TEXAS UTILITIES GENERATING COMPANY

August 20, 1984

SUBJECT: COMANCHE PEAK STEAM ELECTRIC STATION
DOCKET NOS. 50-445 AND 50-446
CPSES CHANGES TO PROPOSED TECHNICAL
SPECIFICATIONS

LIST OF TECHNICAL SPECIFICATION CHANGES

FIGURE 2.1-1
 REACTOR CORE SAFETY LIMIT - FOUR LOOPS IN OPERATION

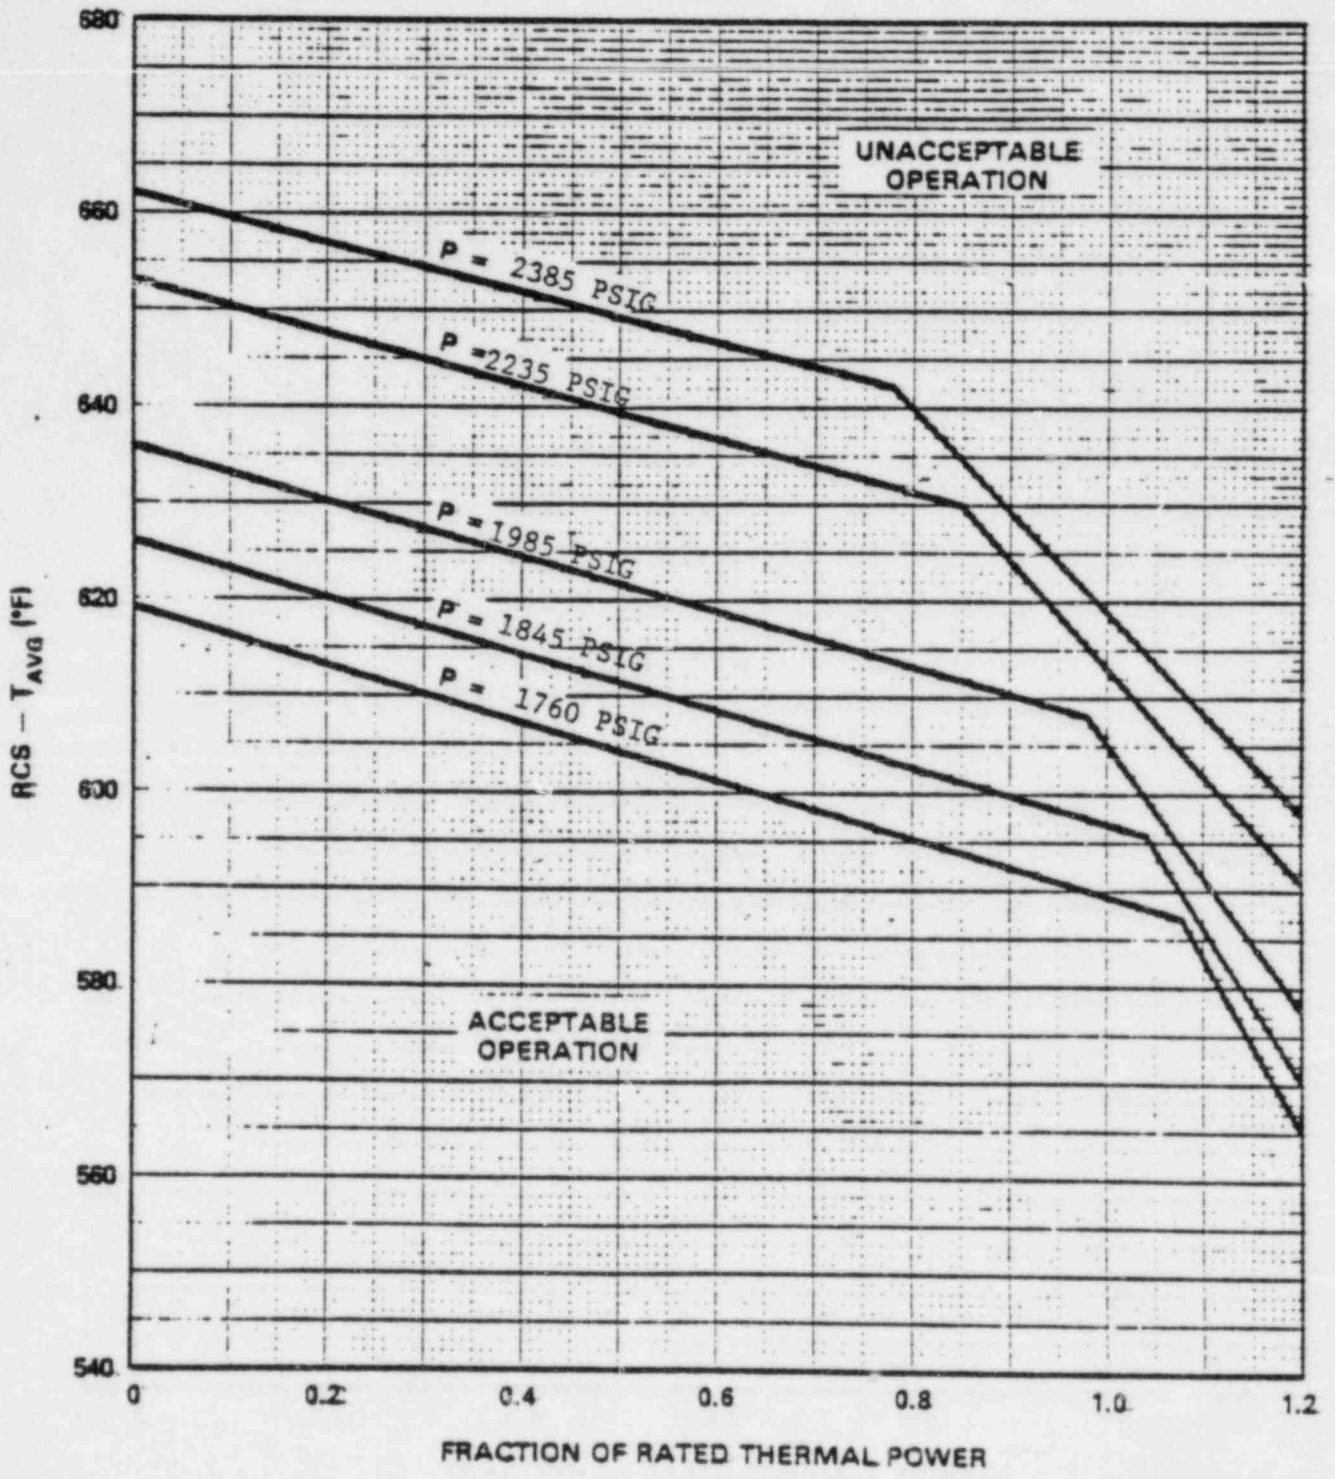
REMOVE

Figure 2.1-2 left blank pending NRC
approval of three loop operation

FIGURE 3.1-1

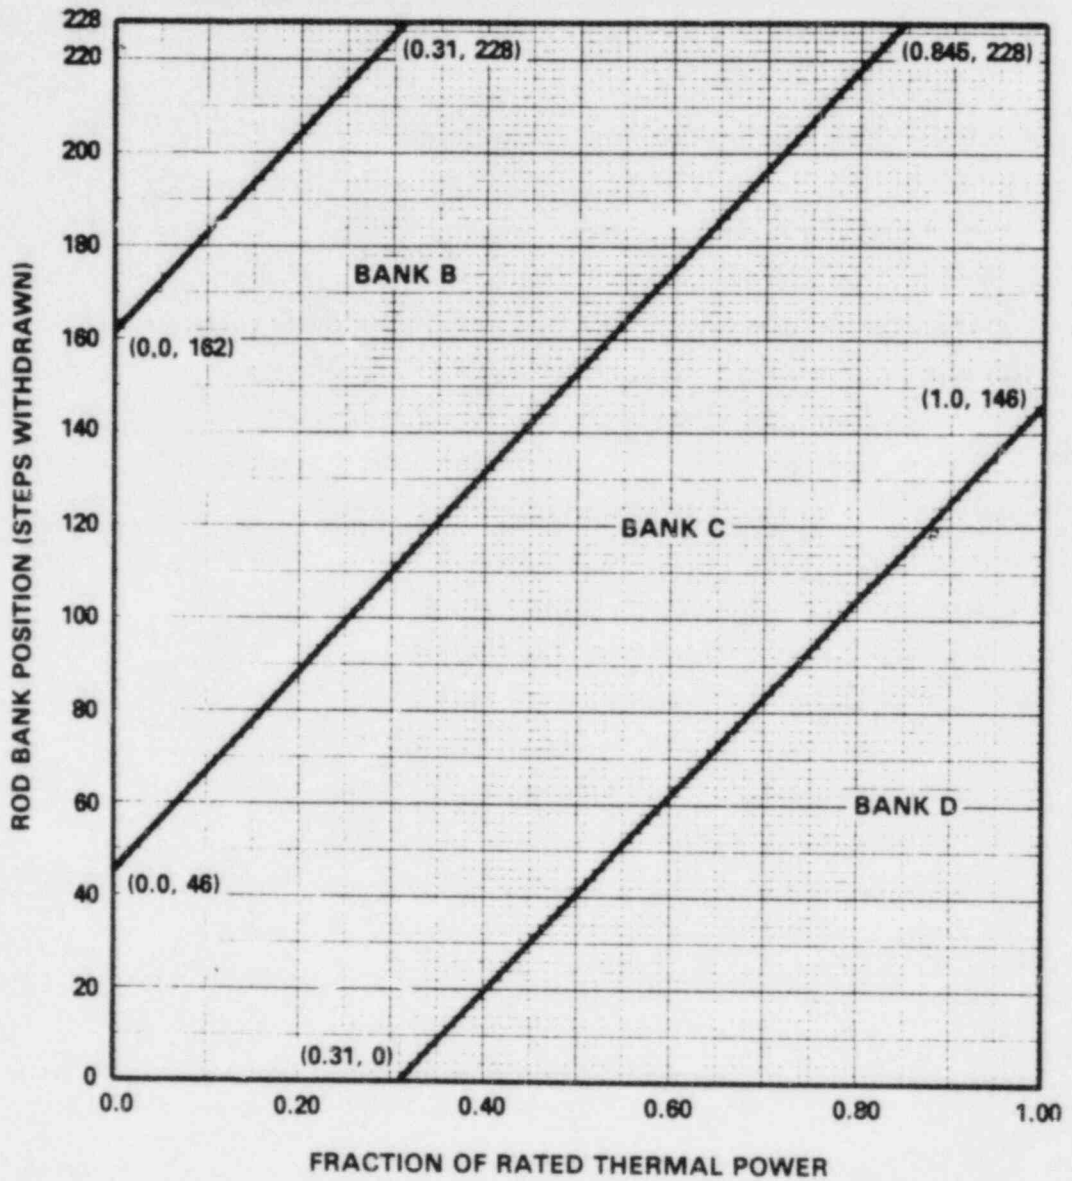
REMOVE

Figure 3.1-2 left blank pending
NRC approval of three loop operation.

FIGURE 3.2-4

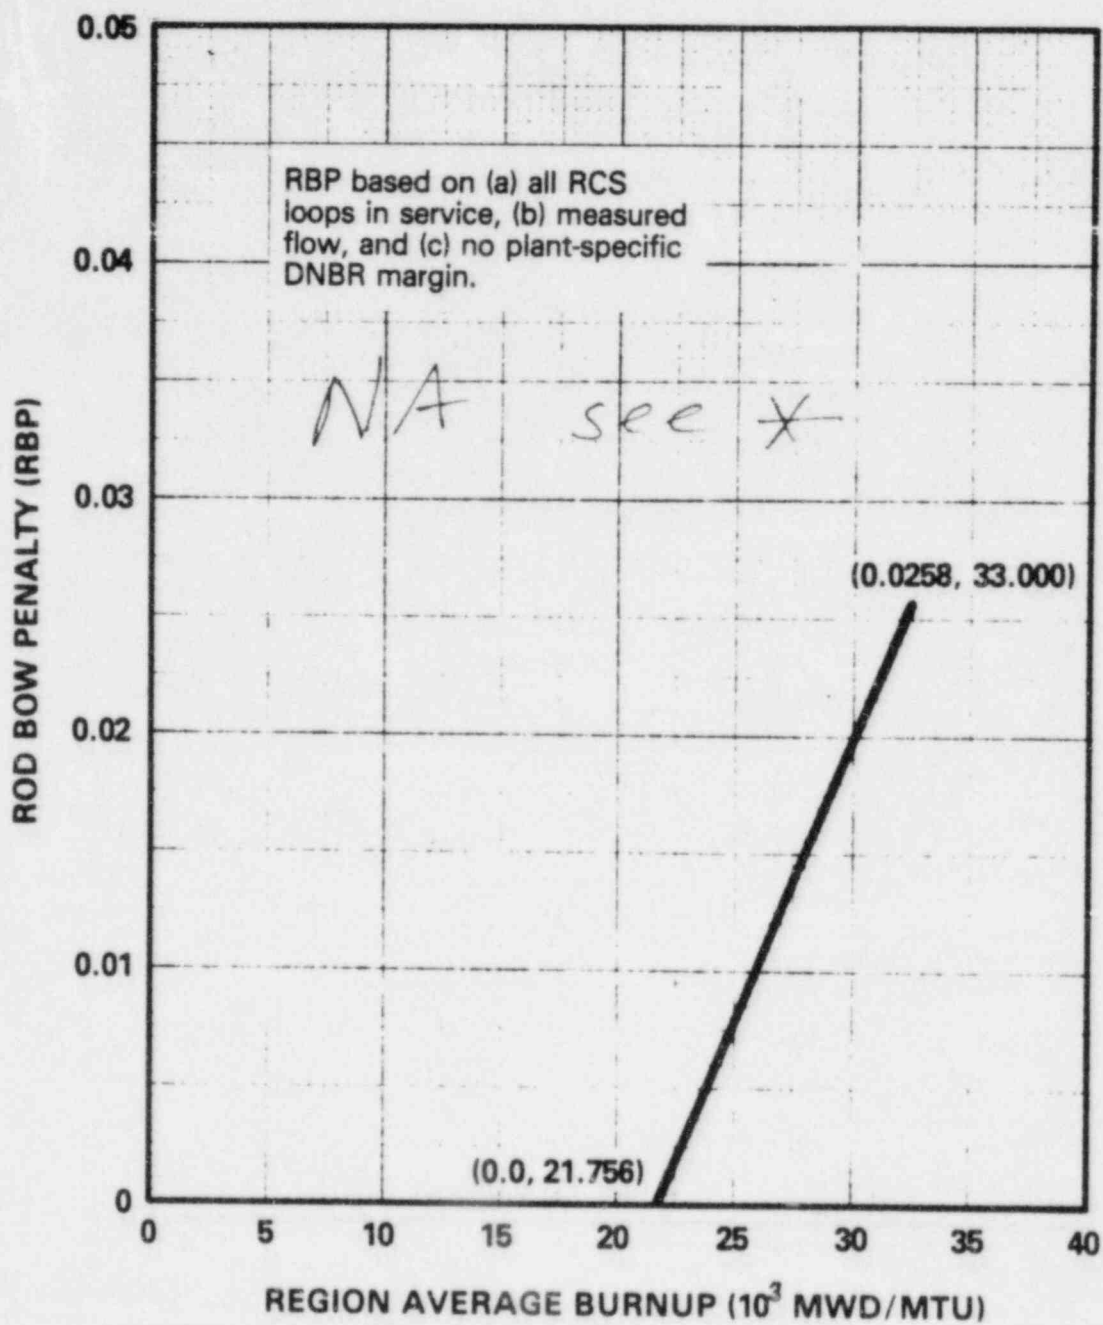
* All of 3/4.2.3 will be changed because NRC has agreed to remove rod bow penalty and review request to lower flow uncertainties to 1.3%

FIGURE 6.2-1

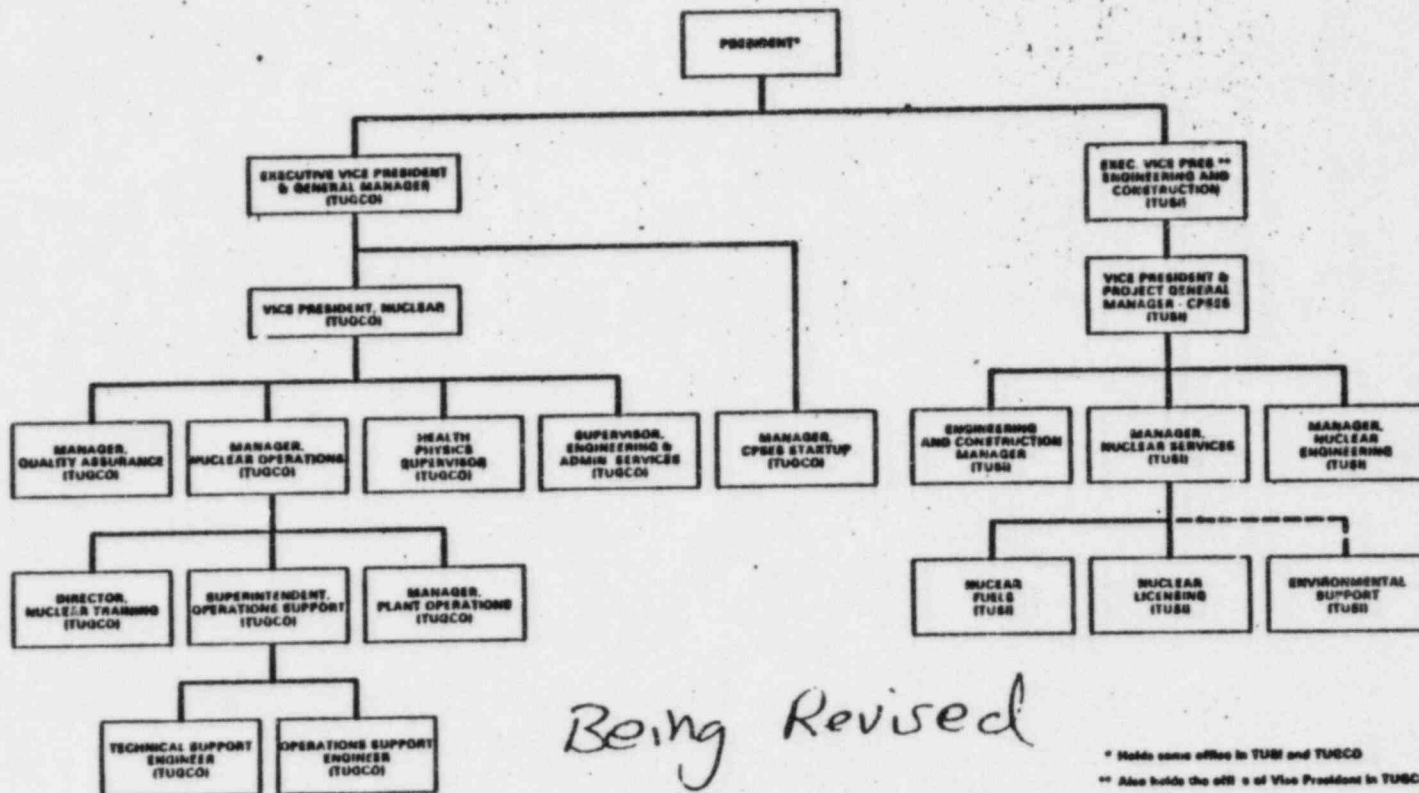
New figure from the FSAR.

FIGURE 6.2-2
UNIT ORGANIZATION

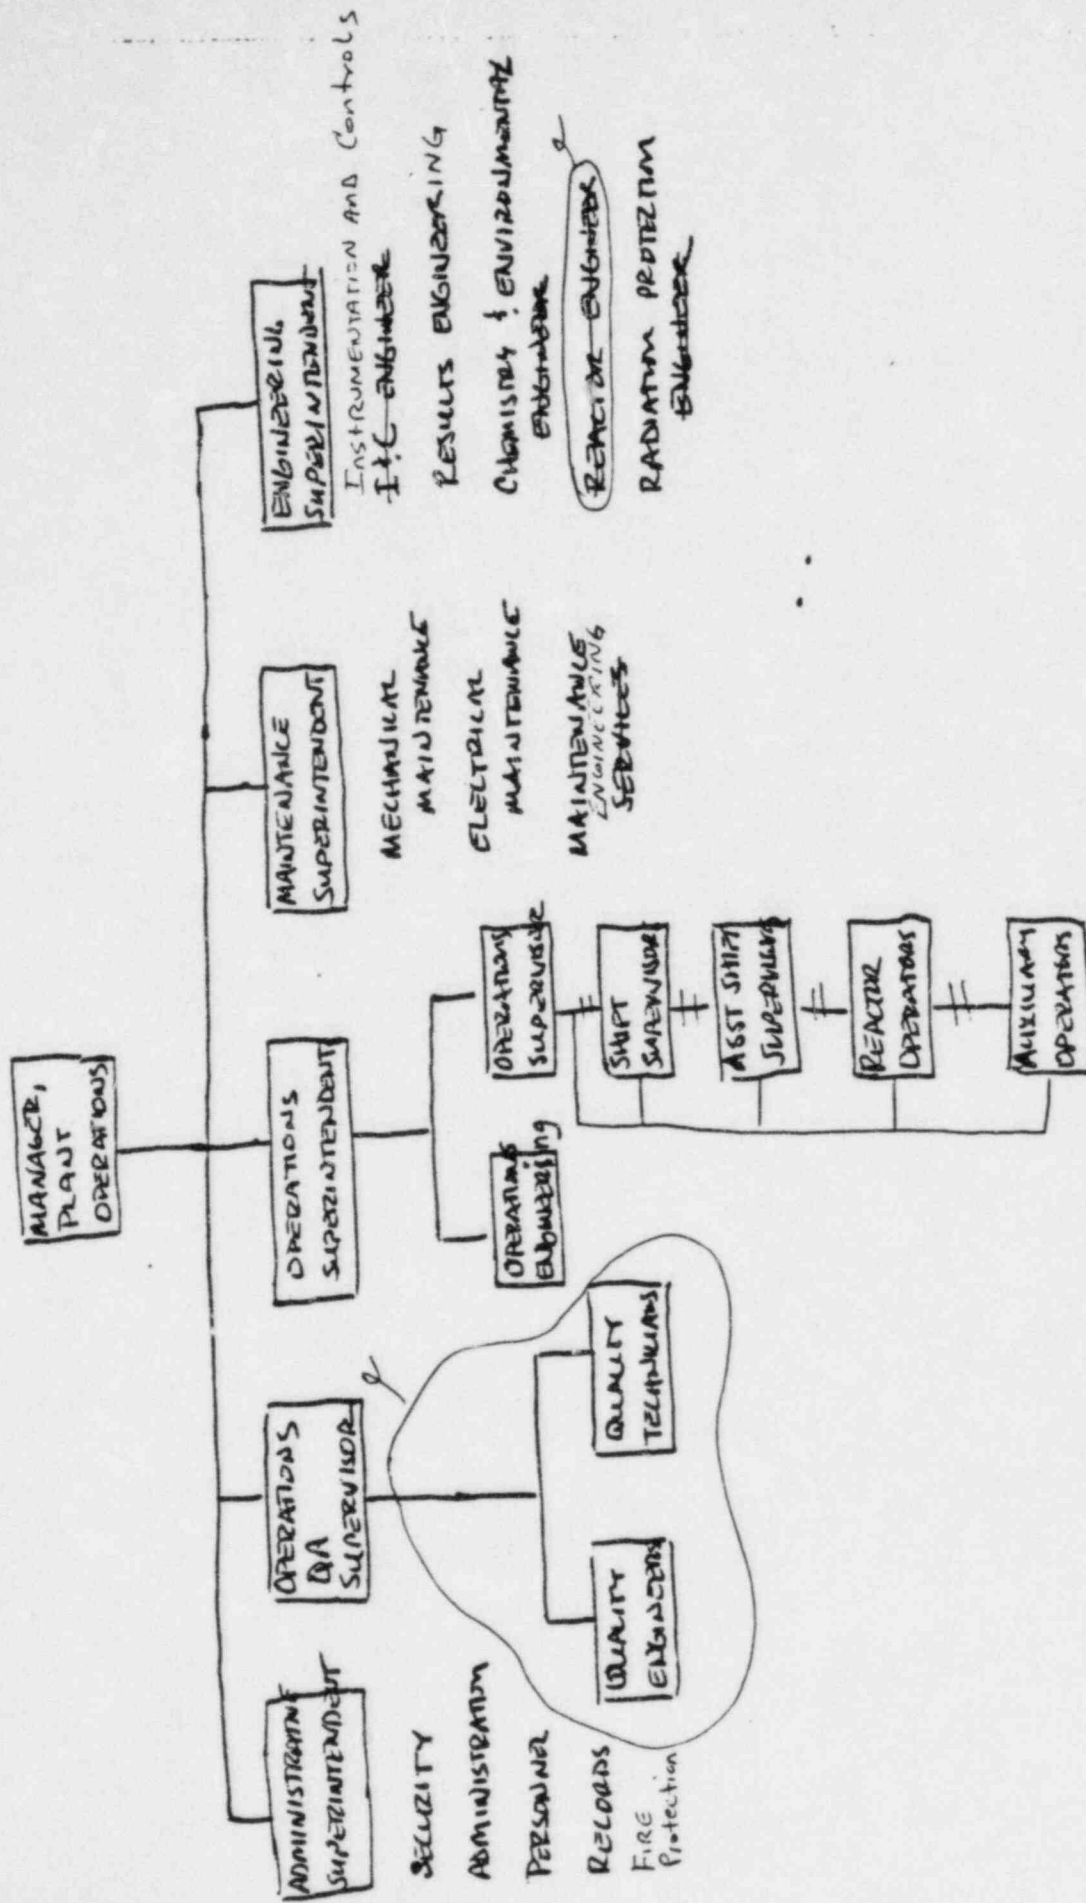
SEE PROPOSED
ORGANIZATION -
ATTACHED
